**Re: Albuquerque Healthcare for the Homeless
1220 First Street NW
Request Permanent C.O. - Accepted
Engineer's Stamp dated: 10-13-15 (J14D172)
Certification dated: 10-27-15**

DRAINAGE AND TRANSPORTATION INFORMATION SHEET (REV 09/2015)

Project Title: Albuquerque Healthcare for the Homeless First Street Expansion **Building Permit #:** _____ **City Drainage #:** J-14/D172
DRB#: 1005251 **EPC#:** _____ **Work Order#:** _____
Legal Description: Tract A, Albuquerque Healthcare for the Homeless, Inc.
City Address: 1220 First Street NW

SUPPLEMENTAL SITE AND DRAINAGE INFORMATION
ALBUQUERQUE HEALTH CARE FOR THE HOMELESS, INC.

GRADING PLAN

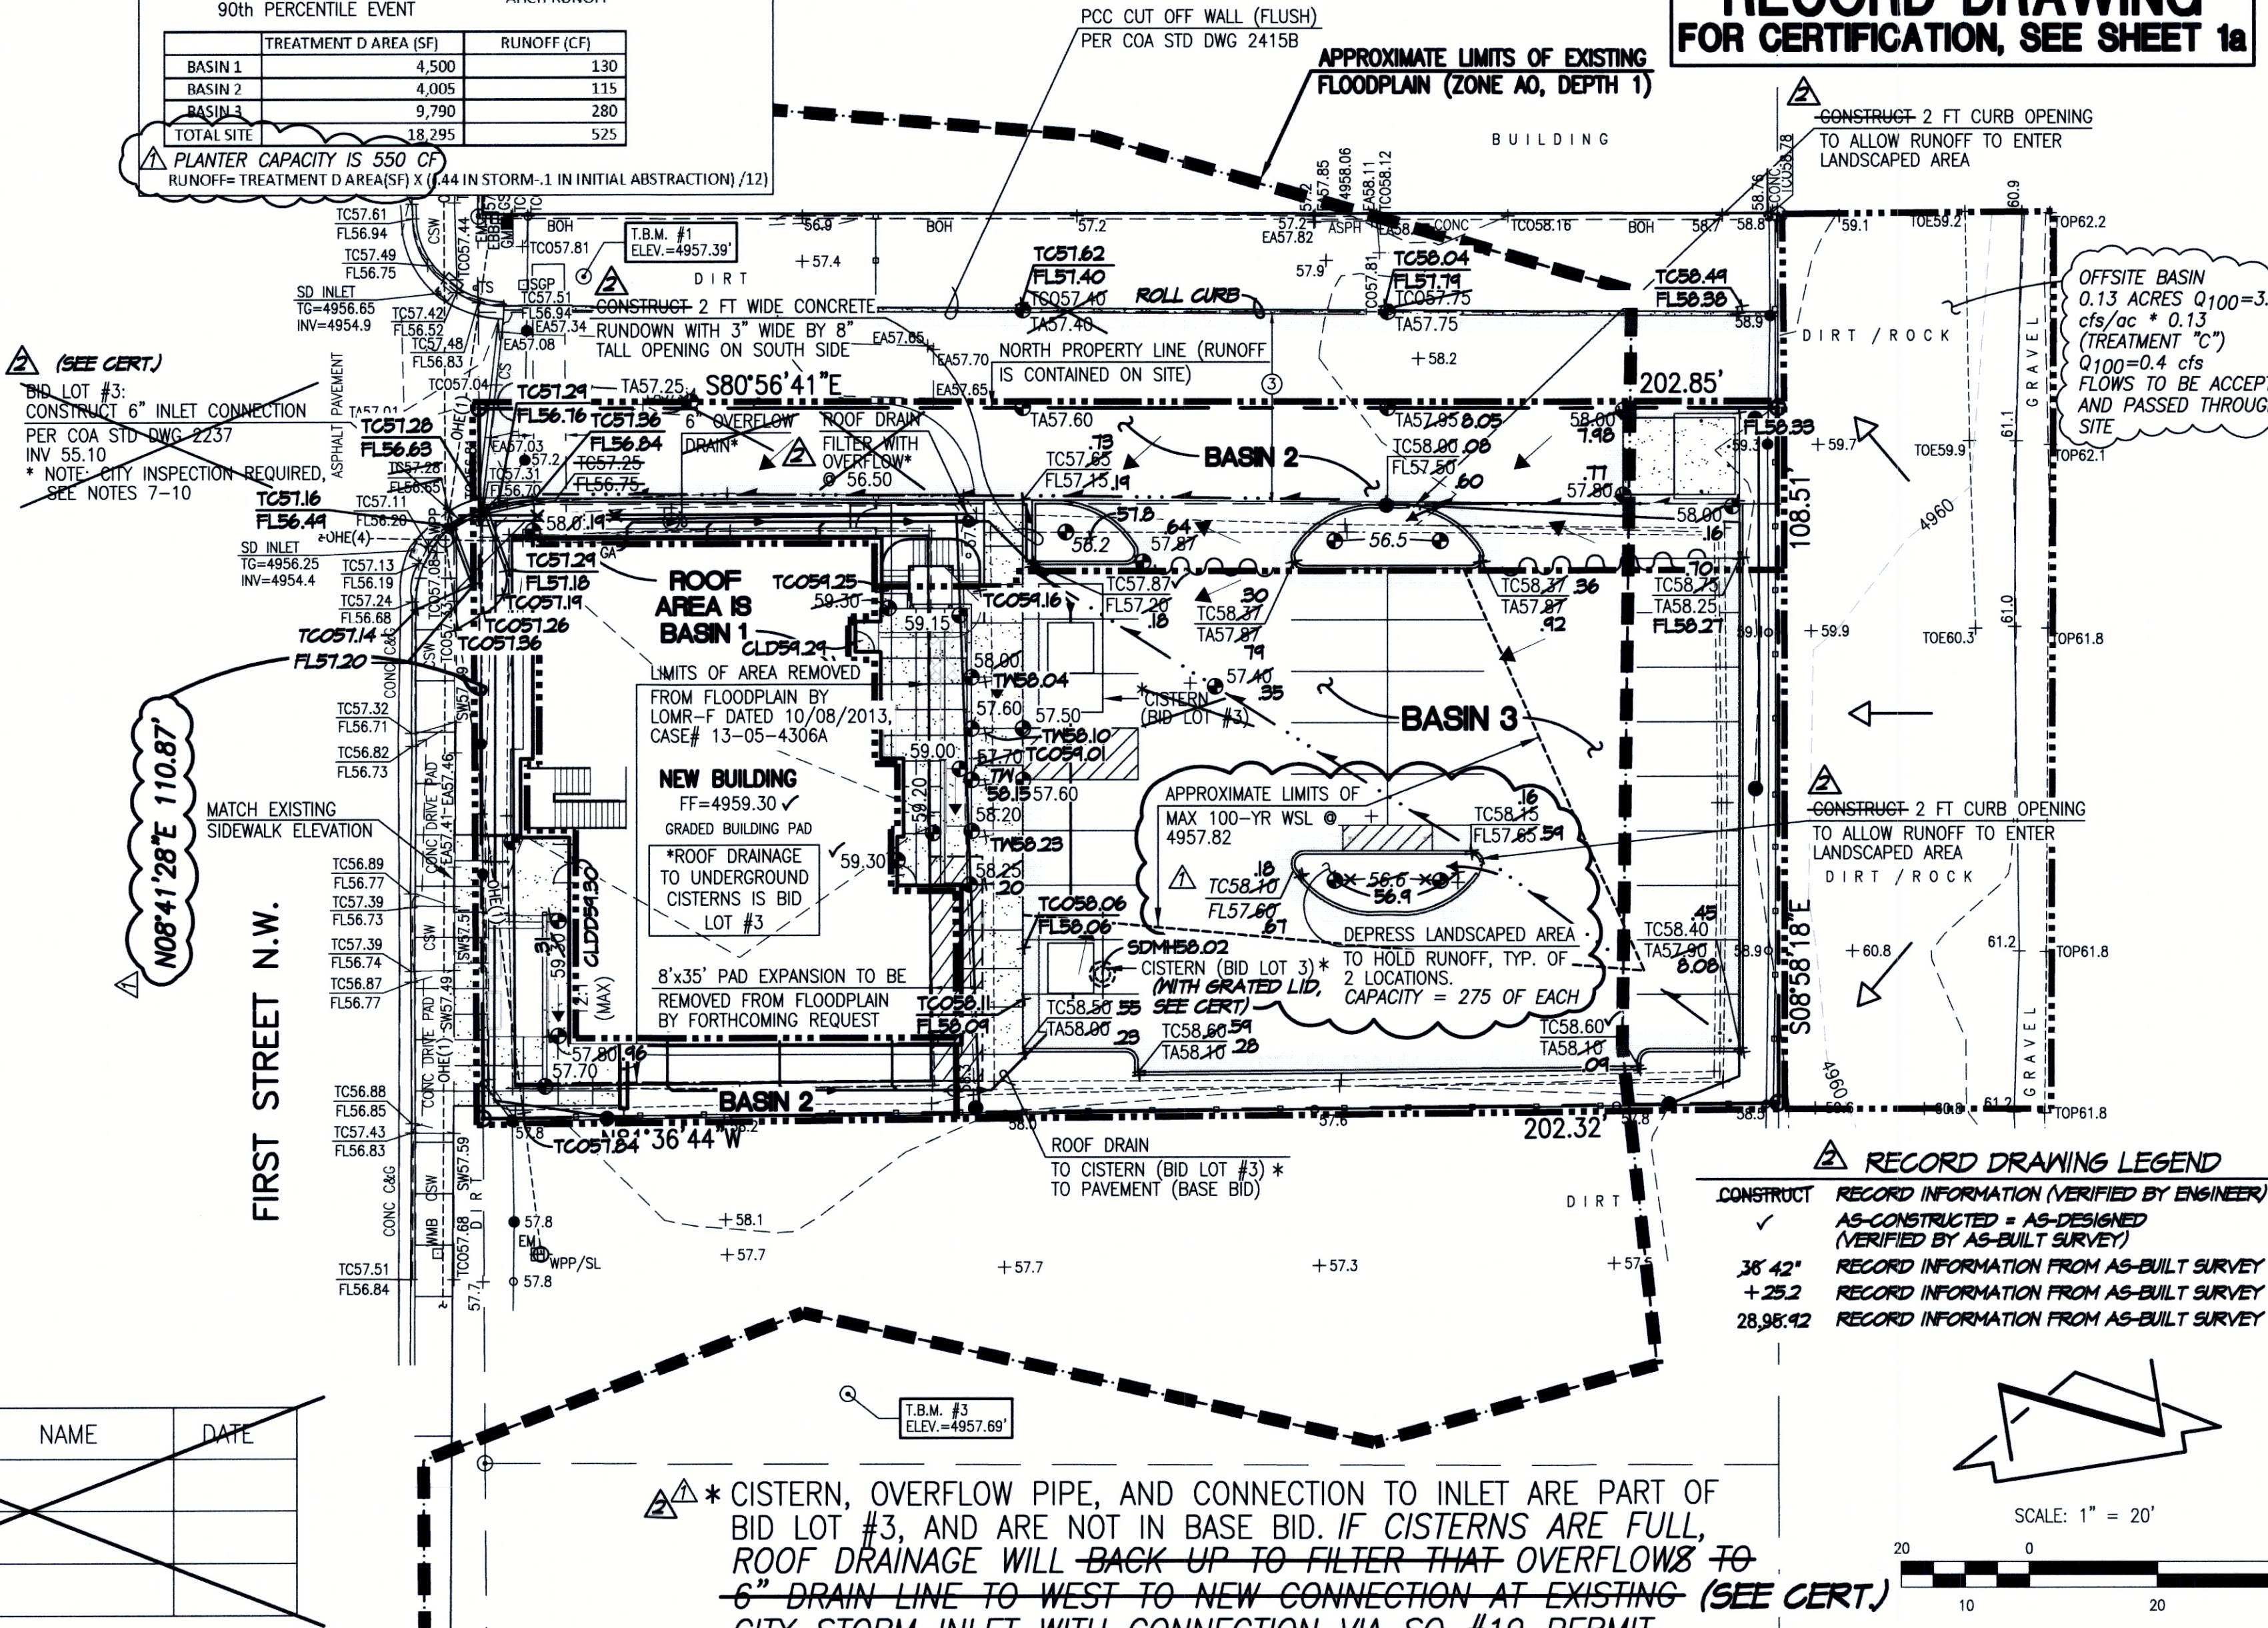
THE FOLLOWING DEVIATION FROM THE APPROVED PLAN THAT DOES NOT PRECLUDE CERTIFICATION OF THE PLAN INTENT WAS NOTED AND IS DOCUMENTED HEREIN:

- 1) THE ROOF DRAINAGE CISTERN SYSTEM DOES NOT INCLUDE AN OVERFLOW PIPE CONNECTING TO THE EXISTING CITY STORM INLET. INSTEAD OF A PIPED OVERFLOW, THE CISTERN ACCESS COVER IN THE PARKING LOT HAS A VENTED LID TO ALLOW OVERFLOW TO DISCHARGE AS SURFACE RUNOFF IN THE PARKING LOT. BECAUSE THERE IS NO PIPED CONNECTION, THERE WAS NO SO#19 WORK ASSOCIATED WITH THIS PROJECT.
